Revisions to Responses to NRC RAI Part 3

RR901-001-02

Rev. A

This document contains the revisions to RR901-001-01, "(HFC) Responses to the NRC's Request for Additional Information (RAI) Part 3 Rev. A, in correspondence to the application of Doosan HF Controls (HFC) Corporation of HFC-6000 Safety System Topical Report, Revision C.

RAI 118 Response

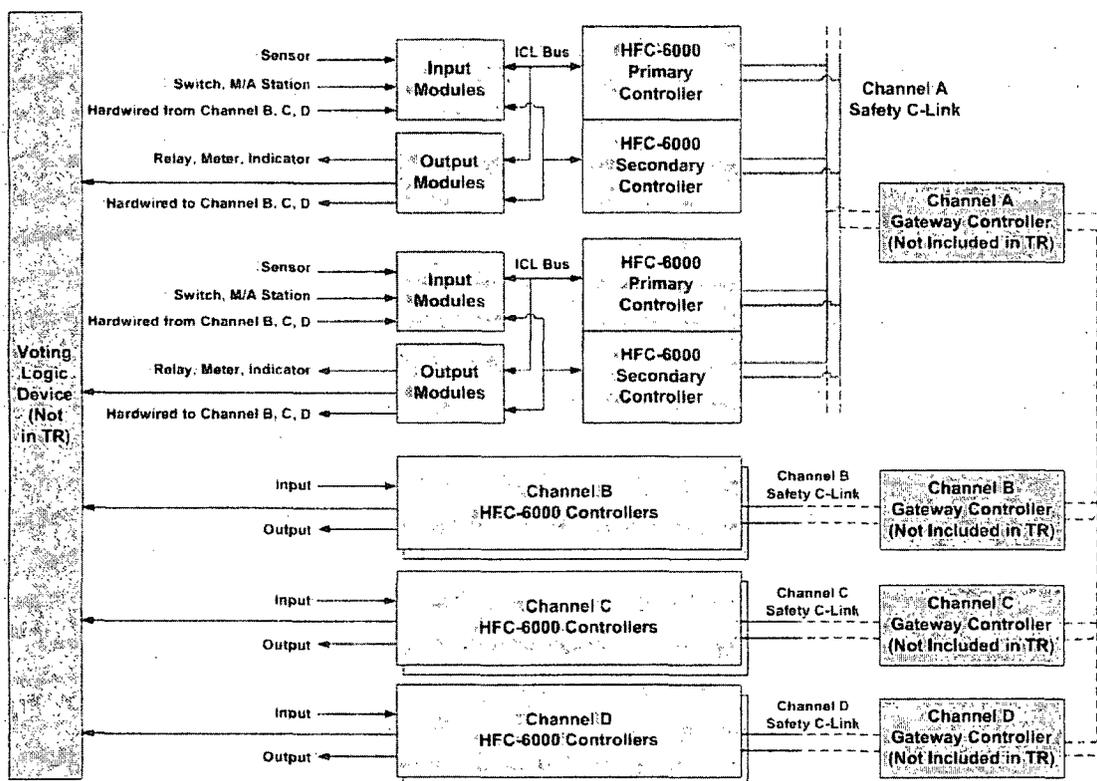
The following figure replaces figure 1 of RR901-001-01, "Responses to RAI Part 3", Rev. A.
